Access Compliance Report

Public Rights-of-Way (Curb Ramps)

Intersection ID: 22573	Main Street: INDIAN_HILLS_LN	Cross Street: SEASCAPE_LN	Location: NE
ADA ID: F79FF1AC2EF9	Ramp Type: Directional1	Initial Pass/Fail: Fail	Overall Compliance: No
Severity Score: 22.5			
Codes/Mitigation Info/Possible Solution		Field Measurements/Component Compliance

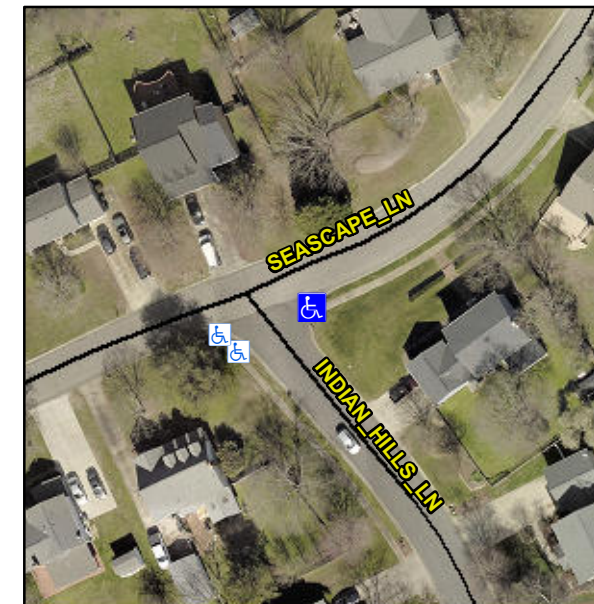
R304.5.1, R304.2.2, R304.5.3

Compliance	Description	Data	Compliance	Description	Data
N/A	Ramp Length (in)	48.0	N/A	Grade Break?	N/A
No	Ramp Width (in)	47.0	N/A	Grade Break Slope (%)	0.0
No	Ramp Slope (%)	9.1	N/A	Grade Break XSlope (%)	0.0
No	Ramp XSlope (%)	4.0			
N/A	Flare Type LT	N/A	N/A	Flare Type RT	N/A
N/A	Flare Slope LT (%)	N/A	N/A	Flare Slope RT (%)	0.0
N/A	Flare Traversable LT?	N/A	N/A	Flare Traversable RT?	N/A
N/A	Landing Length (in)	0.0	N/A	DWS Provided?	N/A
N/A	Landing Width (in)	0.0	N/A	DWS Contrast?	N/A
N/A	Landing Slope (%)	0.0	N/A	DWS Length (in)	N/A
N/A	Landing X Slope (%)	0.0	N/A	DWS Full Width?	N/A
N/A	Landing Curb? (Y/N)	N/A	N/A	DWS Offset LT (in)	N/A
N/A	Shared Landing?	N/A	N/A	DWS Offset RT (in)	N/A
N/A	Gutter Ponding?	0.0	N/A	Gutter Slope (%)	N/A
N/A	Gutter Lip Ht (in)	0.0	N/A	Gutter X Slope (%)	N/A
N/A	Painted X Walk1?	No		Road Slope (%)	2.1
	X Walk 1 Direction	To SW		Road X Slope (%)	1.0
	X Walk 1 Width (in)	N/A		Clear Space?	N/A

X Walk 1 Slope (%)	2.1	N/A	Clear Space to XWalk (in)	N/A
	X Walk 1 X Slope (%)	1.0	N/A	Storm Grate/Utility Hazard?	N/A
N/A	Ramp inside XWalk1?	N/A		Storm Grate/Utility Type	
N/A	Any Obstructions?	N/A			N/A
	Obstruction Type		Yes	Surface Condition? (G/P)	Good
			N/A	Curb Slope (%)	8.8

Remove & Replace Entire Ramp.
